RE: *PyraMax Ceramics, LLC – Wrens, Georgia – Application No. 20584
Volume I and Volume II (Modeling) PSD Permit Application
October 6, 2011 Technical Review Comments Response*

Trinity Consultants (Trinity), on behalf of our client PyraMax Ceramics, LLC (PyraMax), is providing written responses to technical comments received regarding Application No. 20584. The following is a summary of the question received, and our response.

Figure 1. Urbanization Evaluation of Nearest Counties with Ozone Monitors vs. Jefferson County with and without the proposed PyraMax Facility

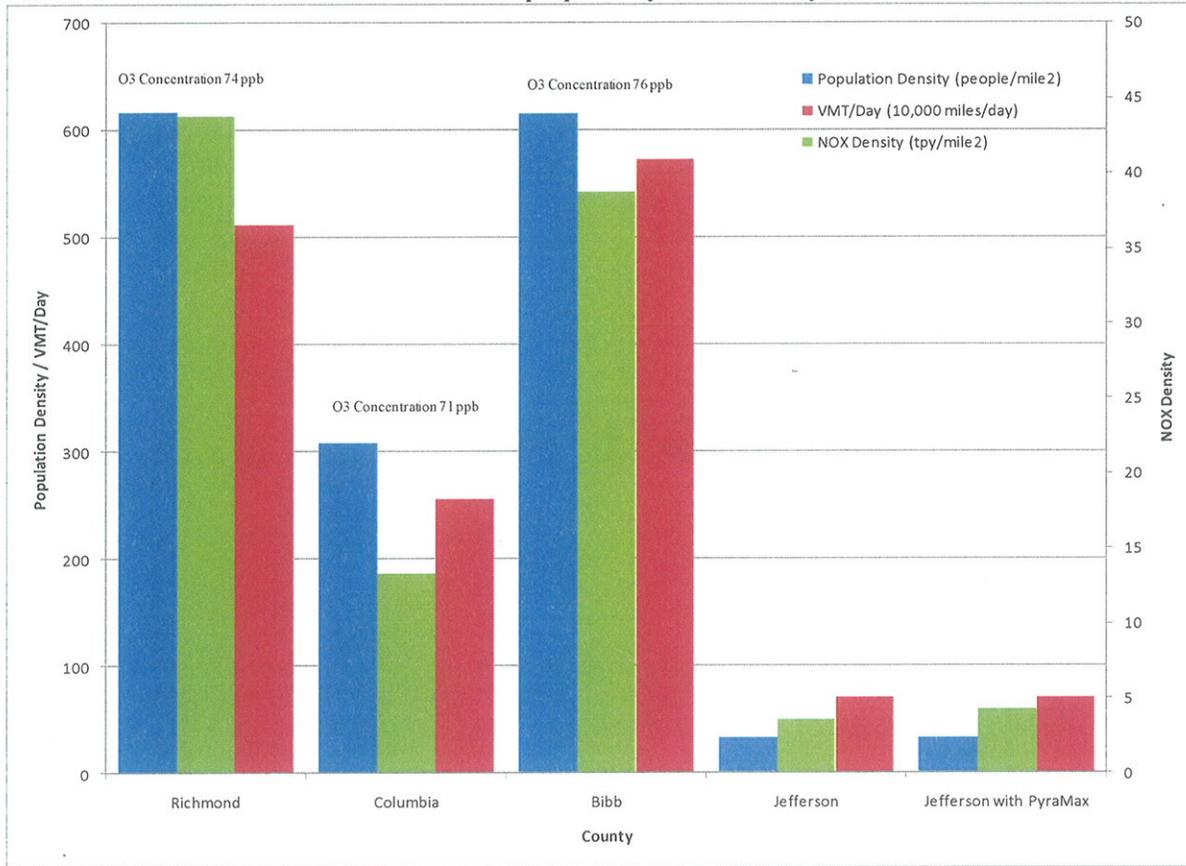
8. *Volume II: The applicant should conduct, document, and submit an ozone impact analysis because the projected NOx emission and VOC emission are both greater than 100 tons per year. Please refer to Appendix A of this letter.*

Ozone is formed when nitrogen oxides (NO_x) and volatile organic compounds (VOC) react in the presence of sunlight. In Georgia, this reaction is NO_x limited due to the presence of high amounts of biogenic VOC. NO_x primarily is emitted from mobile sources and industrial sources. Therefore, ozone formation is directly impacted by NO_x emissions, which is a reflection of population density, vehicle miles travelled (VMT), and industrial NO_x emissions.

Jefferson County has a much lower population density, NO_x density, and VMT than Richmond, Columbia, and Bibb counties. In order to indicate this graphically, the following figure compares these parameters for the three closest monitors and Jefferson County with and without the proposed PyraMax facility. As seen from the figure, of the three monitor locations, Columbia County has the lowest population density, VMT, and NO_x density, and consequently has the lowest monitored ozone concentration, 71 ppb, for 2007 - 2009. Going by the same pattern, Jefferson County has an even lower population density, VMT, and NO_x density and accordingly is expected to have a lower ozone concentration and would therefore be in attainment with the 8-hour ozone standard of 75 ppb. Also, as indicated in the figure below, Jefferson County with the proposed PyraMax facility would still

have NO_x emissions below the levels in any of the three closest counties with monitor locations, and hence is not expected to have a significant impact on the ozone attainment status in Jefferson County. Please note that, in Figure 1, the Jefferson County with PyraMax estimates include an increase in NO_x emissions only, as VMT and population density would not be expected to change significantly as a result of the facility. VMT and population density would most certainly not increase by a significant enough amount to approach the levels seen in Columbia County.

Figure 2. Class I PM_{2.5} SIL Evaluation Results at a Receptor Ring of 10km, 25 km, and 50 km

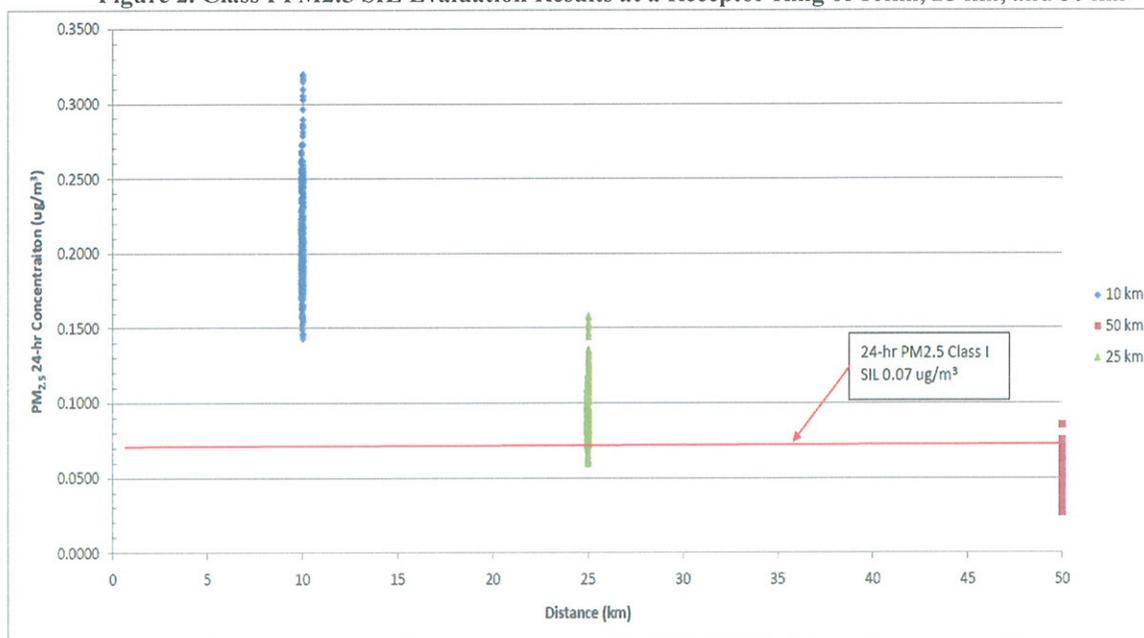
9. *Volume II: Chapter 5* Please prepare a table for submission that compares the maximum modeling concentration and the applicable Class I significant impact levels. This table should include a PM_{2.5} impacts comparison against the Class I PM_{2.5} SILs as these became effective on 12/20/10, independently of the PM_{2.5} Increments.

To provide further support that continued modeling for this issue is not warranted, a model was run at a receptor ring distance of both 10 km and 25 km. A scatter plot of the 24-hr average results for PM_{2.5} at those distances is shown in Figure 2 below.

As can be seen from this data scatter plot, there is a definitive drop off in predicted modeled concentrations with distance. With the rate of decline seen in concentrations in distance it is unlikely that concentrations above the 24-hr PM_{2.5} Class I SIL would persist much past a distance of 50 km.
